## **Enclosure 3**

Response to Discussion Initiators for KHNP/NRC Reactor Systems  
Public Teleconference

October 27, 2015

## Response to Discussion Initiators for KHNP/NRC Reactor Systems Public Teleconference: October 28, 2015

Figure 2. Calculation Flow of CPCS Axial Power Distribution

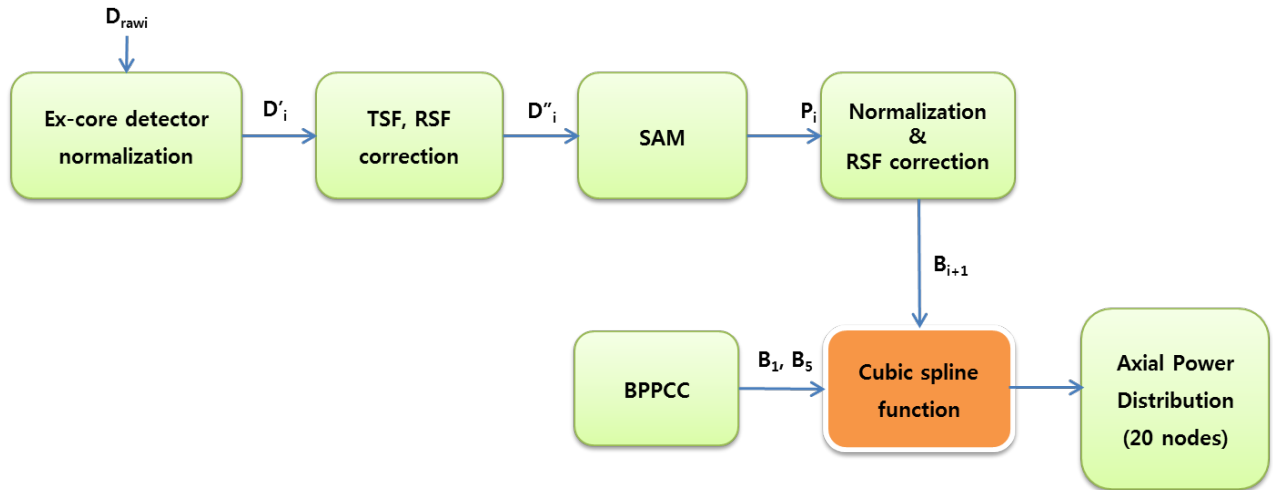
- a. The staff has been reviewing the related submittals and ERR documents but has not yet been able to gain a clear and consistent understanding of how shape annealing functions and related inputs are determined and used.
- b. Are there additional documents that could be submitted or added to the ERR that provide clearer and more comprehensive discussions of these topics?

The CPCS axial power distribution is synthesized from response of the three element ex-core detector string. Figure 2 shows the calculation flow of CPCS axial power distribution. SAM (Shape Annealing Matrix) and BPPCC (Boundary Point Power Correlation Coefficients) are applied to the normalized 3-level ex-core detector signals to give 3-level peripheral power integrals (See Figure 3).
